Service Bulletin

Bulletin No. 2012-70R1 OEM No. 2012-68R1
Circulate to:	Sales Manager	Accounting	Service Manager	Technician	Parts Manager
Zeus M	lidsection Pla	ate Corrosi	ion Repair		
			NOTICE		
	This bulletin replaces service bulletin 2012-70 issued December 2012.				
Models A	Affected				
	Models Covered				
		ZEUS	S HH, IH, & JH PODS

View from below with the seawater intake cover removed

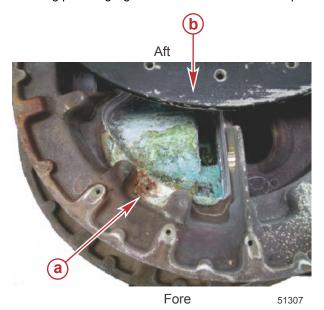
In some applications, minor pinholes or pitting corrosion may occur on the midsection plate near the MerCathode anode assembly. When this occurs, a putty repair kit is available for repairing the bronze midsection plate.

In other applications, if only heavy green/blue corrosion exists in the cavity as shown below, further corrosion can be prevented by installing a new anode assembly. A new MerCathode backing plate and screws should also be installed.

The following photo highlights the area of the midsection plate that could be affected.

- a Corroded area with pinhole
- b Seawater intake cover removed

If minor pinholes or pitting corrosion is found, then only the putty repair kit (8M0074256) must be utilized.

If corrosion is evident with no pinholes or pitting (green/blue colors,) the anode assembly kit (8M0074249) and the MerCathode backing plate and screws (8M8025265) should be installed.
